1500 N. Shoreline
Project Consistency Comments

On July 28, 2023, the following comments were provided to the applicant of 1500 N. Shoreline regarding the proposed project plans and materials submitted to staff. Although these items are not required to be addressed for the project application to be complete, they provide information to the applicant on which aspects of the project are inconsistent with City standards, regulations, and policies.

Figure 2.A Urban Design Diagram

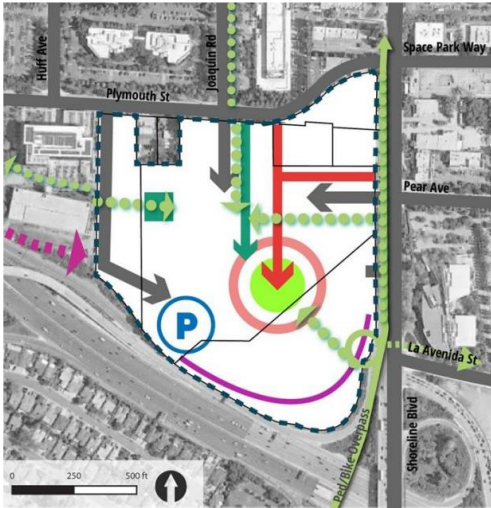
The proposed project varies from these plans in that: a centralized open space area (“Gateway Park/Dog Park”) is proposed south of the Pear Avenue and Joaquin Road intersection, but the southern portion of the open space designated as a “dog park” narrows considerably and makes a sharp turn to the east that terminates in a proposed street (Loop Street) as opposed to connecting the project open space to and integrating with the NBMP open space area (to the south). This concept differs from what was proposed for the SB330 Preliminary Application and the intent of the Centralized Open Space area envisioned by the NBPP and Master Plan, and implemented in the adjacent NBMP (see below).

- a. The NBPP and Master Plan show the locations for retail as a natural extension from the east side of N. Shoreline Blvd. at Pear Avenue to the west side of N. Shoreline Avenue along Pear Avenue. This creates a synergy and visibly attractive location for retail/restaurant uses along N. Shoreline Blvd. for uses in the area, particularly for visitors of the Shoreline Amphitheatre and nearby office uses, and would create pedestrian-activation and retail shopfronts along N. Shoreline Blvd. and Pear Ave. The NBPP and Master Plan envision higher plate height ground floor uses with transparent windows and recognizable building entries close to the street as shown by the red arrows in the Gateway Master Plan Diagram above.

typical of dog parks, and would be an area for community gatherings, events and active use areas. Staff suggests realigning the project open space to provide for a large central vertical open space with a more better aligned and wide-open space connecting to the NBMP open space area to the south.

North Bayshore Master Plan (partial plan)

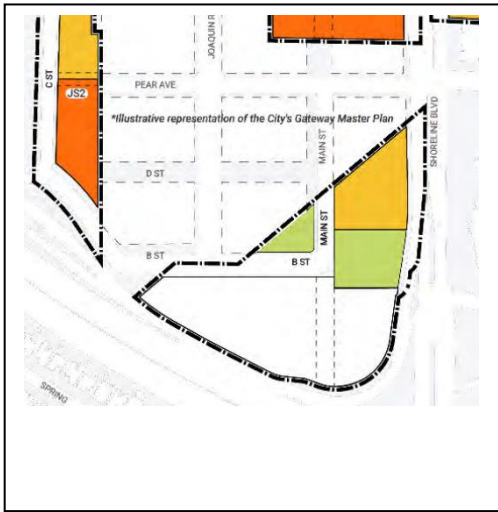
- b. Additionally, the following aspects of the proposed open space design and building layout are inconsistent with the open space planning in the NBPP and Master Plan:
 - The “dog park” concept is not included in either the NBPP or Master Plan, nor was it discussed during review of the Preliminary Application. This concept does not seem to blend in with the overall vision for a large Centralized Open Space area between this site and the adjacent NBMP open space, as the intention is to create a truly open space that is not fenced in or blocked off, as
